**TWIN CITY WATER AND SEWER DISTRICT EAST 1ST ST., UHRICHSVILLE, OHIO
TUSCARAWAS COUNTY, OHIO
PROPOSED
WATER MAIN AND PAVEMENT RESURFACING**

ADDENDUM # 1

**JANUARY 20, 2021
Thrasher Project #101-010-10014**

TWIN CITY WATER AND SEWER DISTRICT
EAST 1st. STREET, UHRICHVILLE, OHIO
WATER MAIN AND PAVEMENT RESURFACING
TUSCARAWAS COUNTY, OHIO
SUMMARY OF QUANTITIES

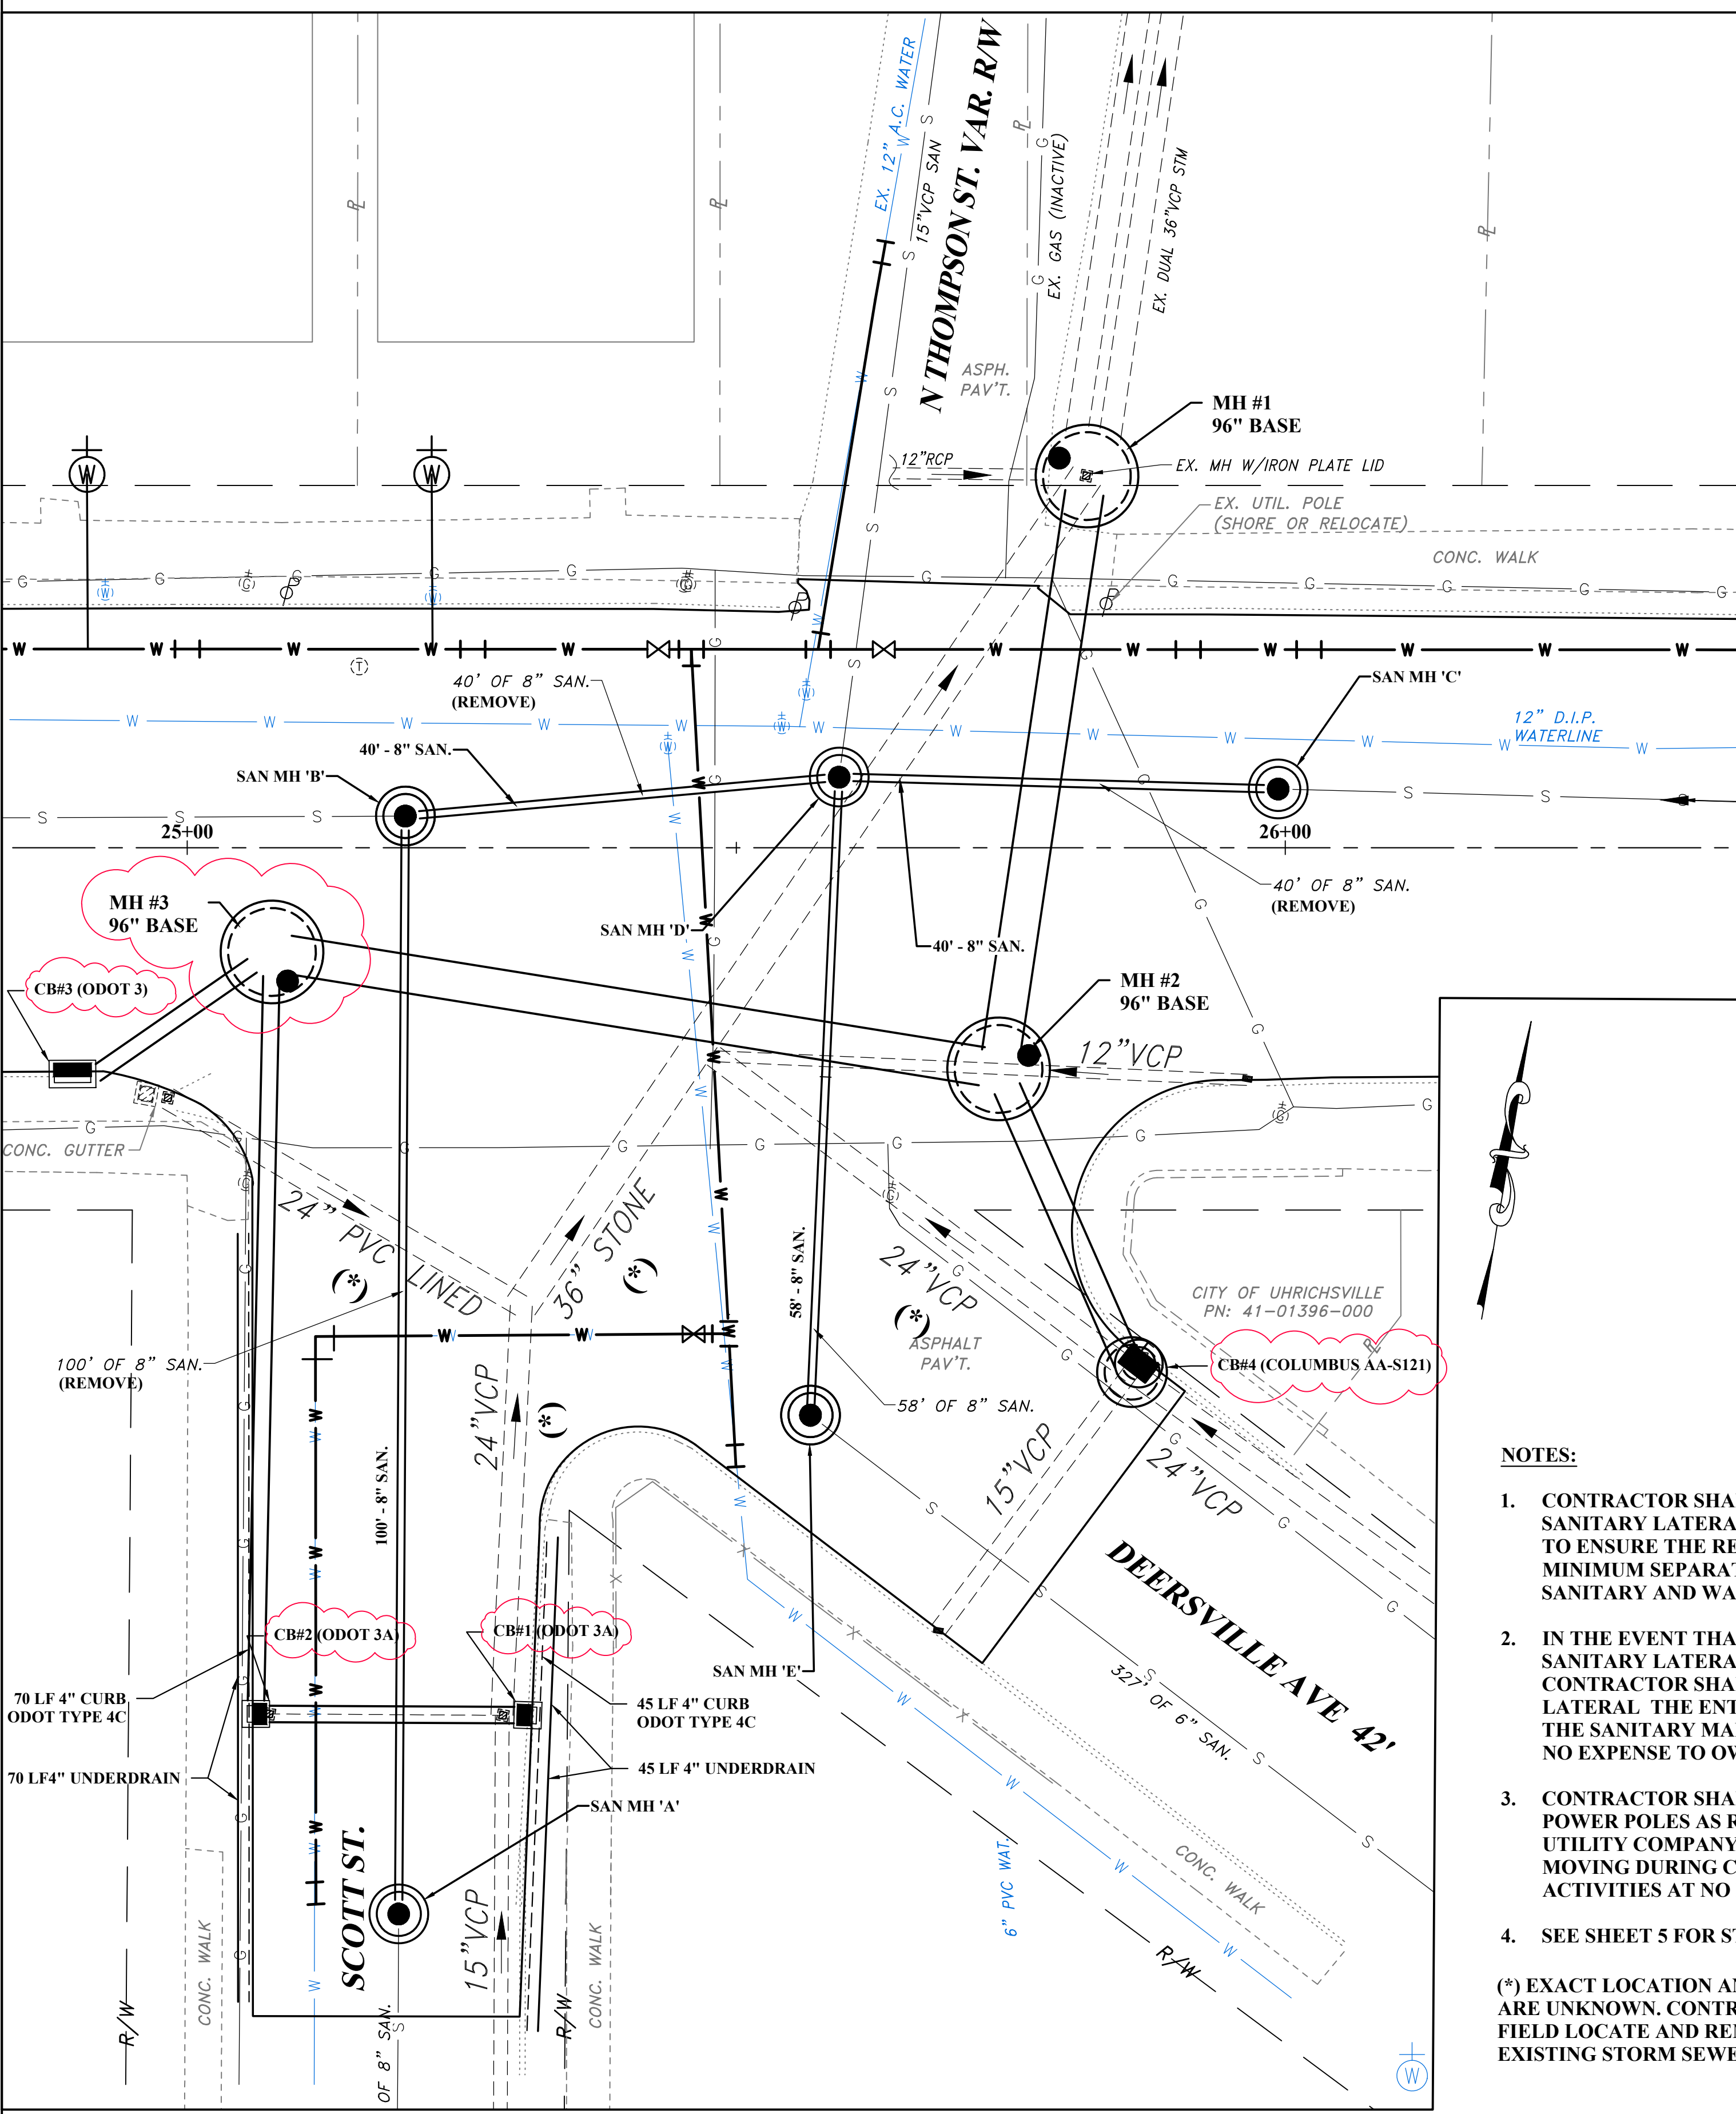
- Added Twin City Water and Sewer District address
6. Plan Sheet 5: Quantities
 - Revised Structure Table
 - Changed Tack Coat quantity from 560 Gal to 983 Gal

- Changed Sanitary Manhole, Type 3 from 4 Each to 1 Each
 - Changed Sanitary Manhole, Type 3 with drop from 1 Each to 4 Each
 - Changed Sanitary Manhole Removed from 2 to 3 Each

- Changed 8” PVC SDR-35 from 550 LF to 238 LF
7. Plan Sheet 15: Storm Sewer Profiles
 - Added storm sewer text
 8. Plan Sheet 16: Sanitary Sewer Profiles
 - Removed the text “Remove and Replace” from sanitary manholes A,B,C and E
 - Revised existing sanitary text
 9. Plan Sheet 19: Standard Details
 - Changed waterline trench detail with crushed stone cover to sand
 10. Plan Sheet 20: Standard Details
 - Changed Utility Trench Detail label to read Storm/Sanitary Utility Detail
 11. Plan Sheet 22: Standard Details
 - Added Sanitary Manhole Drop Structure detail
 12. Plan Sheet 24: Standard Details
 - Added Catch Basin/Manhole #4 Detail
 - Changed the max outlet diameter for MH#4 Detail from 24” to 30”

3. The san schedule has 4 ea manholes and 1 ea drop manhole (sht 5), then on the san profiles (sht 16) basically all the manholes are detailed as drop manholes. Are they all to be drop manholes?

There will be 4 drop MHs and 1 conventional MH. San schedule has been adjusted.

1	JAB	1/19/21	ADDENDUM#1 QUANTITY CORRECTIONS TO MANHOLES/TACK COAT
NO.	BY	DATE	DESCRIPTION
